8XC196MD Manual Supplement 8XC196MC Manual Errata

8XC196MD SUPPLEMENT TO 8XC196MC USER'S MANUAL 8XC196MC MANUAL ERRATA

Errata for 8XC196MC User's Manual, #272181-001

Figure 1.1. 8XC196MC Block Diagram

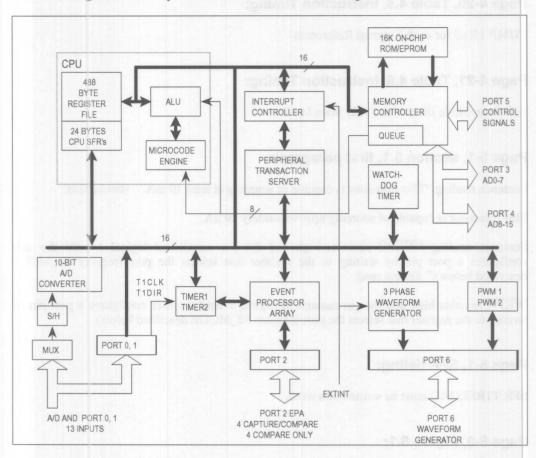
Page 1-1, figure 1.1 8XC196MC Block Diagram

The block diagram is not very accurate. Use this new block diagram:

Figure 6.1. EPA Timer/Counters

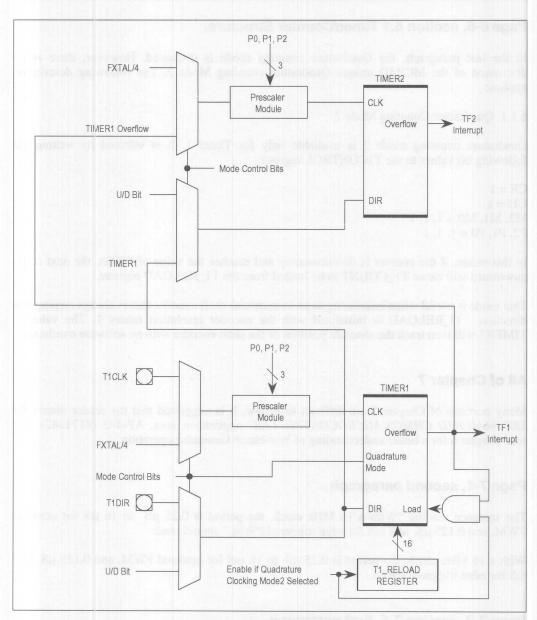
Page 6-2, Figure 6.1:

Figure 6.1 EPA Timer/Counters is incorrect. The corrected drawing is given here:

Figure 11.x. Interrupt Sharing

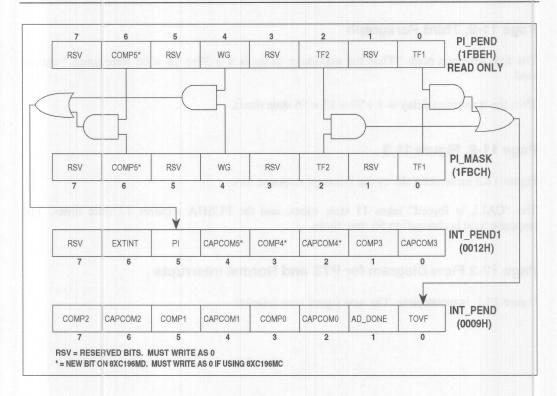
Page 11-4, section 11.1.1

The manual left out the following information:

The PI_PEND register is a read only SFR. PI_PEND is cleared when read, so if more than one bit needs to be checked the register must be preserved in a "shadow" register. Writes to this register will have no effect.

Also note that the PI_PEND register multiplexes the TF1 and TF2 interrupts to the TOVF pending bit in INT_PEND, and the WG interrupt causes the PI pending bit to be set in INT_PEND1. The following figure clarifies this:

Figure 12.1. Flow Diagram for PTS and Normal Interrupts

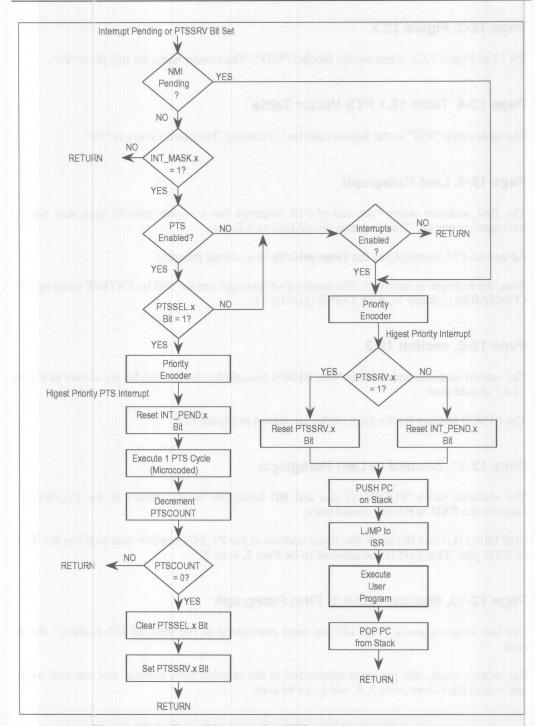
Page 12-2 Flow Diagram for PTS and Normal Interrupts

Figure 12.1. is incomplete. The new figure is as follows:
